DRV8305-Q1 CSA(CurrentShuntAmplifier) Blanking Time : Enable

Figure 12. Current Shunt Amplifier Simplified Block Diagram

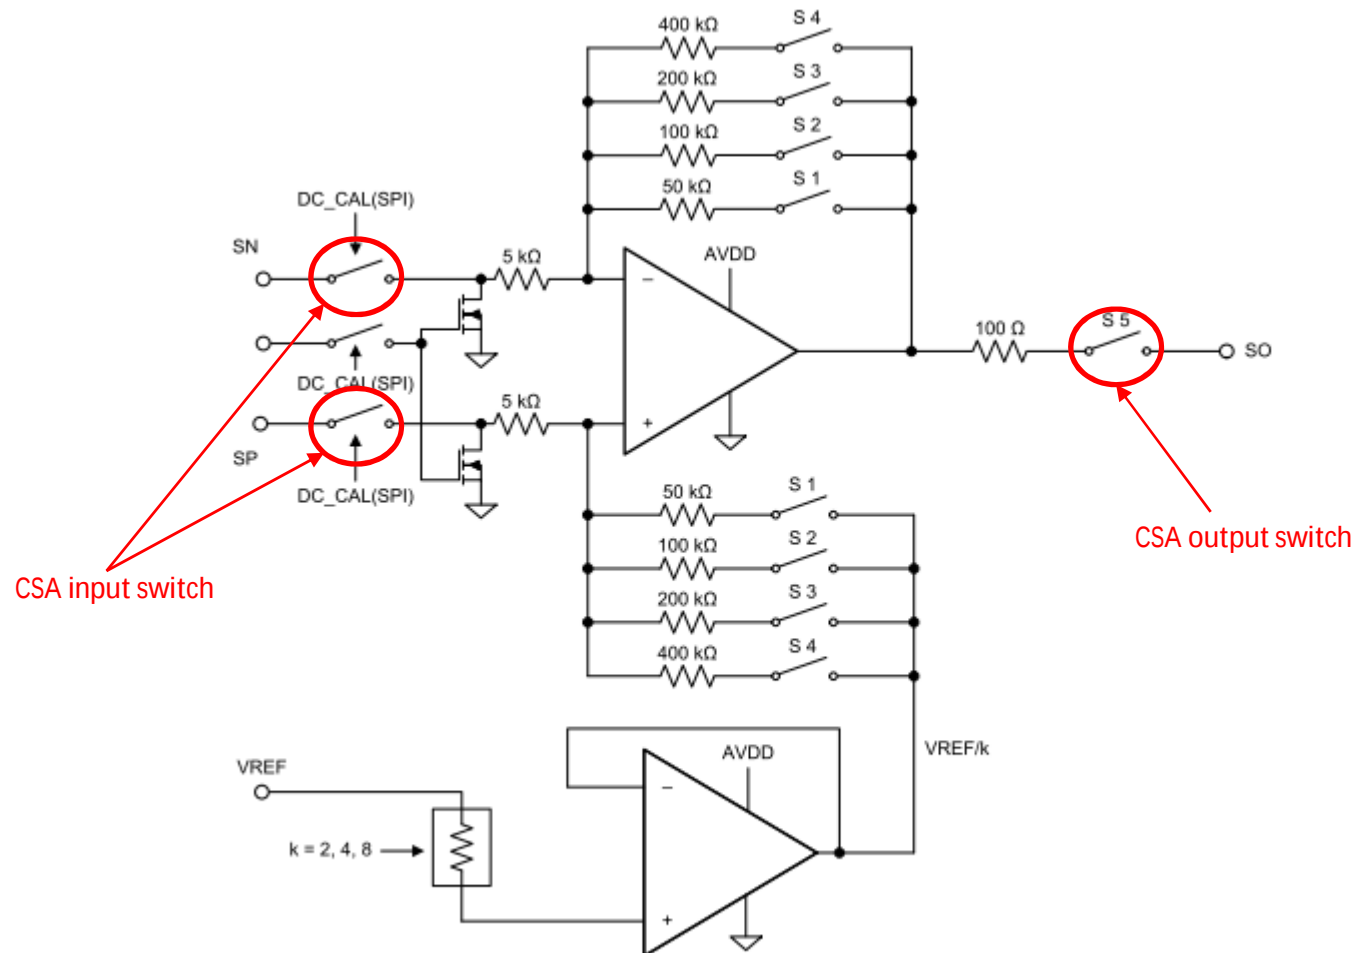
When Blanking Time is enabled,

CaseA : Input switch and output switch of CSA turn OFF

CaseB : Input switch of CSA turn OFF

CaseC : Output switch of CSA turn OFF

Which one is correct?
